SUBJECT: ISSUANCE OF AMENDMENT - JOSEPH M. FARLEY NUCLEAR PLANT, UNIT 1 (TAC NO. M98268)

SUBJECT: ISSUANCE OF AMENDMENT - JOSEPH M. FARLEY NUCLEAR PLANT, UNIT 1 (TAC NO. M98268)

AMENDMENT TO FACILITY OPERATING LICENSE

SAFETY EVALUATION BY THE OFFICE OF NUCLEAR REACTOR REGULATION RELATED TO AMENDMENT NO.128 TO FACILITY OPERATING LICENSE NO. NPF-2

FIGURE 3.4-1

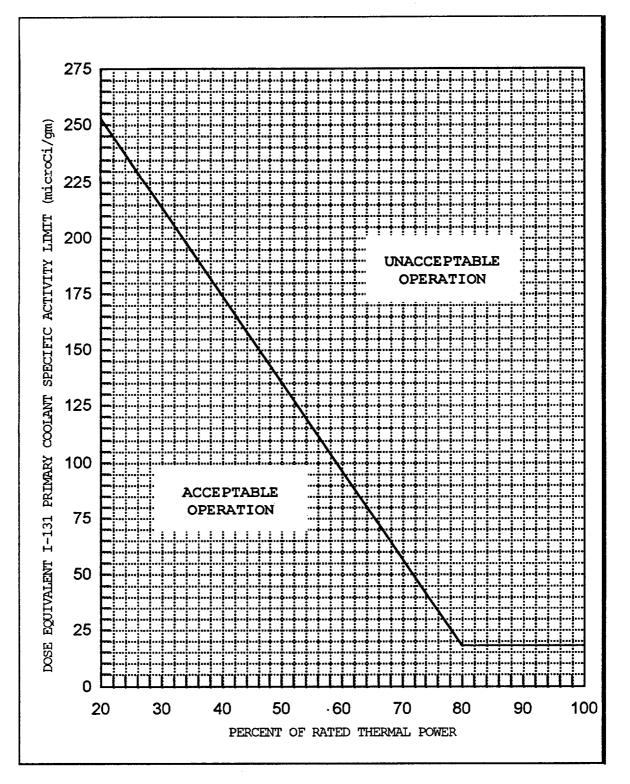
DOSE EQUIVALENT I-131 Primary Coolant Specific Activity Limit Versus Percent of RATED THERMAL POWER with the Primary Coolant Specific Activity > 0.3 μ Ci/gram Dose Equivalent I-131

The ACTION statement permitting POWER OPERATION to continue for limited time periods with the primary coolant's specific activity greater than 0.3 microCuries/gram DOSE EQUIVALENT I-131, but within the allowable limit shown on Figure 3.4-1, accommodates possible iodine spiking phenomenon which may occur following changes in THERMAL POWER.
